From: Jason M. Hockstok, P.E.
Date: February 14, 2003
Job no.: 2001-1008
Re: Streets of West Chester – Retail
 Building 3

**RETAIL BUILDINGS 1 & 3
ACCESS DRIVE EXHIBIT**
THE STREETS OF WEST CHESTER
PREPARED BY:

From: Eric Pottenger
To: "JHockstok@emht.com".gwia.BCEO
Date: Tuesday, February 18, 2003 8:15AM
Subject: RE: Streets of West Chester

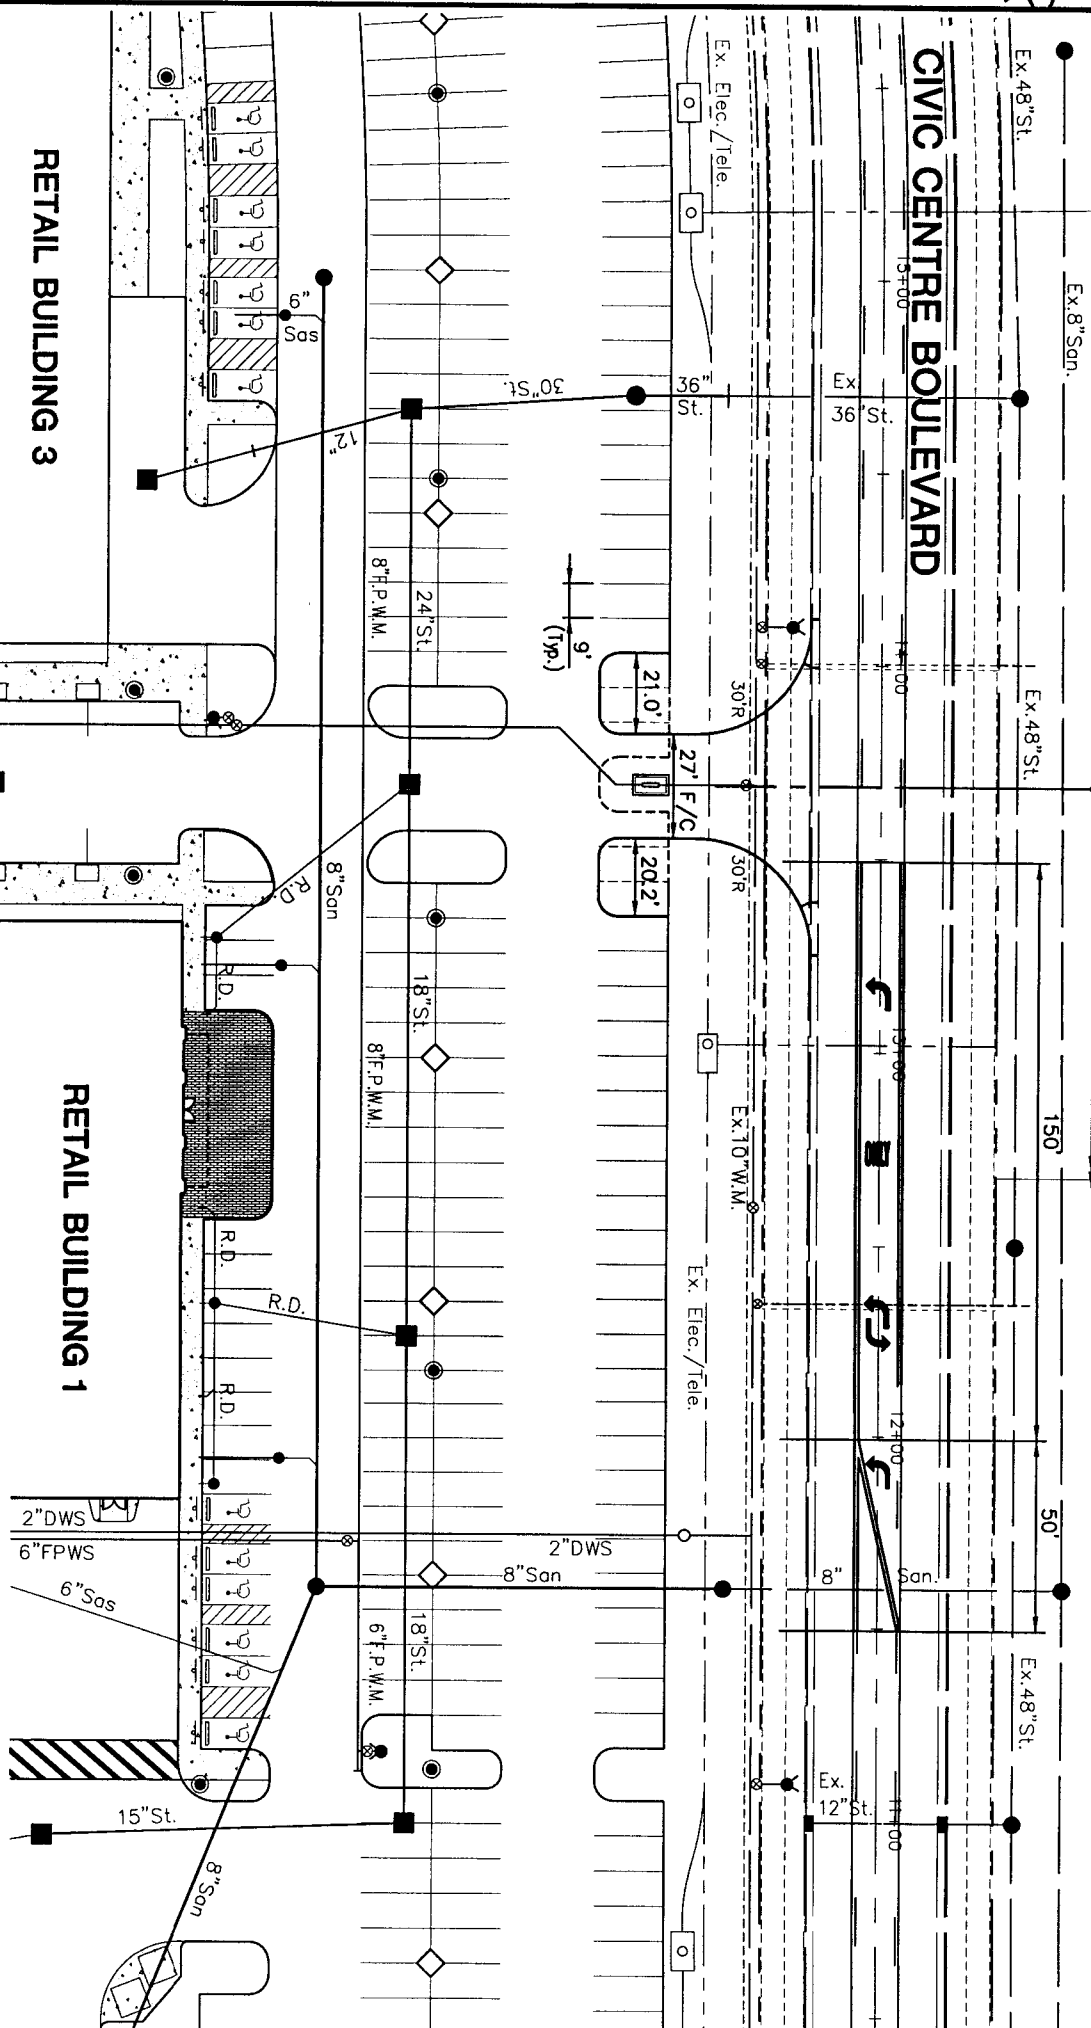
Thanks for the revised drawings. However, I would like to see where the other driveway is proposed that Sean and Amy discussed. Adjacent driveways are to align and should not be offset. Please show the driveway location on the north side of Civic Centre Boulevard.

Good morning. I took a look into our file and found we have all ready determined driveway location for the parcels on the west side of Civic Center. I believe Amy Pursley sent Sean Cullen a fax of these locations. With the new drive you proposed, there is an offset of driveways. I think in order to make the proposed drive work, we will have to adjust the drive locations on the west side of Civic Center. Also, the drive width looks fairly narrow & the radii small. We recommend larger radii and an entrance more like 28' B/C.

Eric - The attached retail entrance has been revised as requested and is resubmitted for approval. We have opened up the radii (30') and the driveway has been widened (27 F/C or 28' B/C). Please feel free to call with any comments. Have a good weekend.
